PR/0007/23

Record of Executive Business and Chief Executive's Order

Reg. Reference: SDZ22A/0010

Submission Type: Additional
Information

Figure 2 roads and junction layout from SDZ

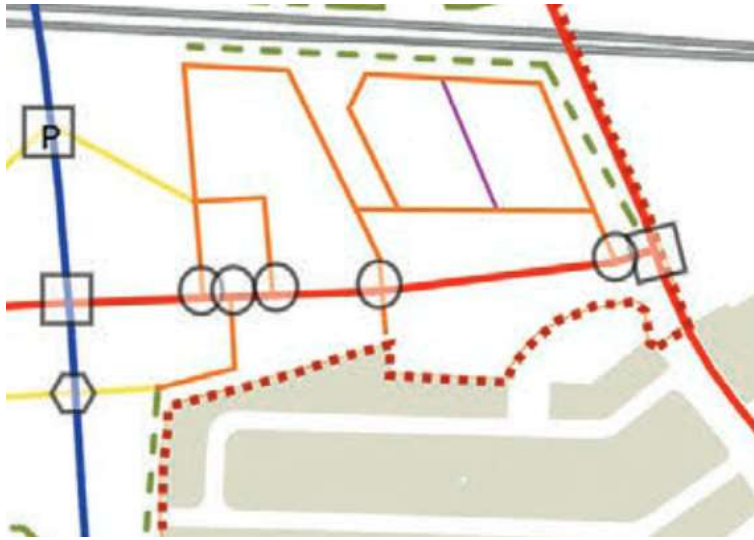
The roads layout is somewhat like the SDZ, there is a link road missing across the middle section. The number of junctions onto the main east-west link road (SDZ20A/0021) correspond to the proposed layout.

Figure 4 roads layout from SD20AA/0021

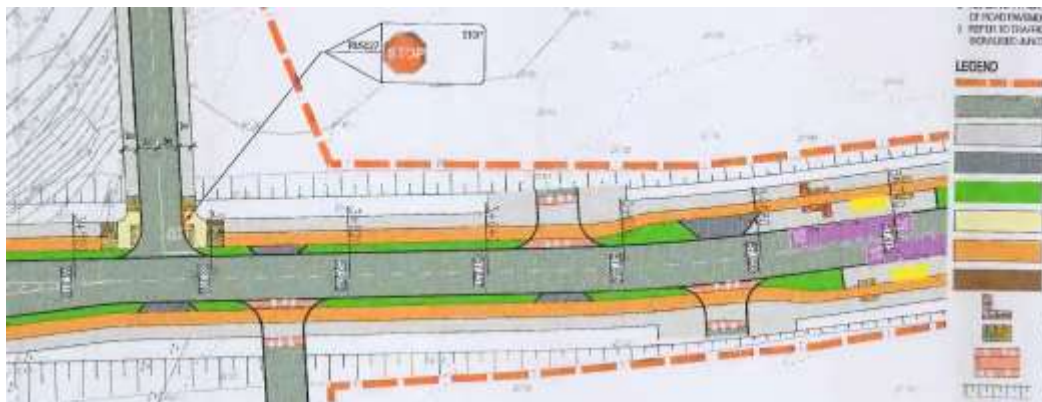
Figure 5 parallel parking on both sides of the road.

Sightlines for the developments junctions have been provided and are adequate. An Autotrack showing fire tender access to the development has been provided and is satisfactory. Refuse vehicle auto tracking is also sufficient.

Figure 7 road cross sections.

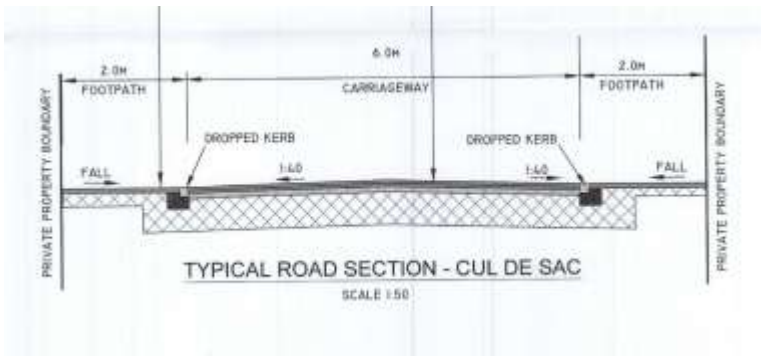
The applicant has provided road cross section details, the details refer to “Cul De Sac” they should refer to the road types identified in the road’s layout plan, i.e., Homezone, Link Road etc. and should match the dimensions overall widths and parking arrangements of the road types provided in the SDZ planning scheme.

Figure 2.2.6 | Example Local Streets including Horseman (Intimate Scale)

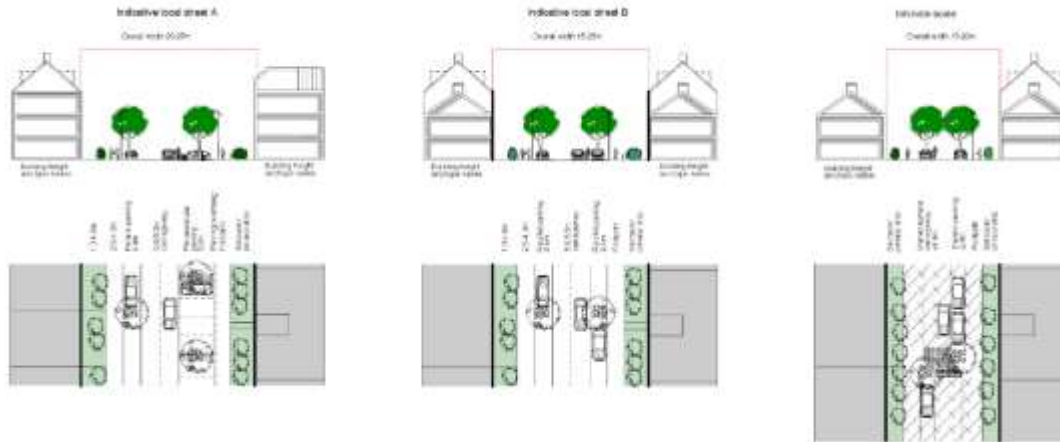
The proposed overall street widths are largely in line with the Planning Scheme. However, the Planning Authority does have concerns in relation to the allocation of space within these, particularly the Local Streets and Intimate Local Streets. Reference is made to Figure 2.2.6 in the Planning Scheme.

The Planning Authority has concerns about the level of perpendicular car parking on the local streets and the on curtilage parking in intimate local streets. The footpaths on the local street are approx. 2m when they should be 2.5-4.0m. Intimate Local Streets should be fully shared surfaces for the integrated movement of vehicles, pedestrians and cyclists in quieter residential areas. The intimate local street in the east of the site should be significantly redesigned in line with the Planning Scheme. The applicant is requested to submit revised plans indicating revised details via **additional information**. Cross sections should also be provided.

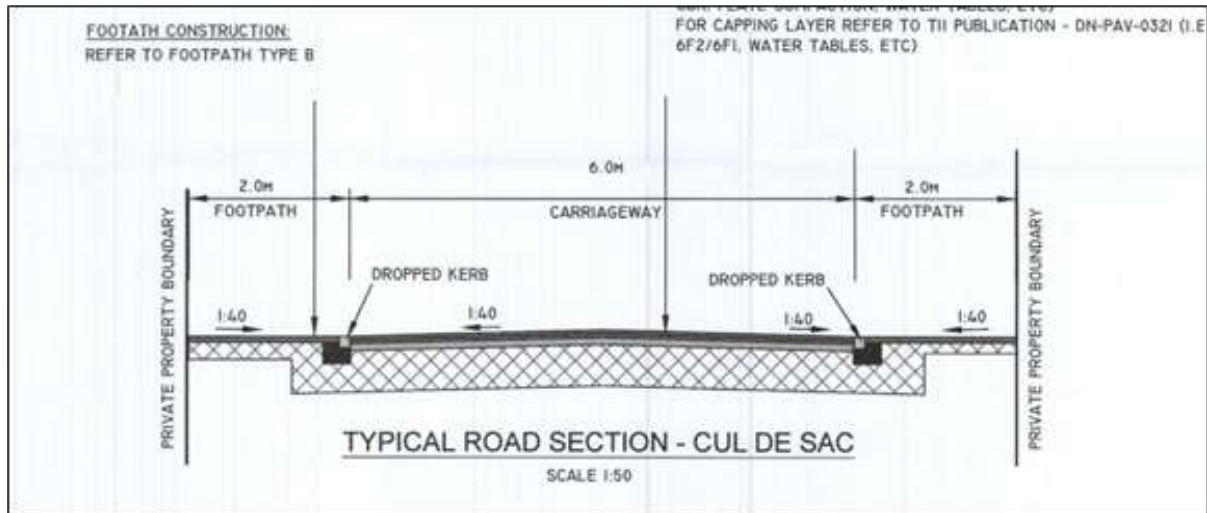
- *would not significantly affect the prescribed alignment or centre line of any fixed street;* Parts of streets are not provided in some places including around the urban plaza and at the eastern entrance to the SDZ lands. However, it is noted the layout is influenced by the permitted Link Street and it is desirable to not have streets completely encasing the urban plaza.

- *would not significantly affect prescribed building lines of any fixed street;* The fixed building lines as prescribed in the Planning Scheme have been adjusted, particularly in CUC-S4. However, they are considered to have been largely provided for, even if adjusted slightly in terms of location or how they are broken up.
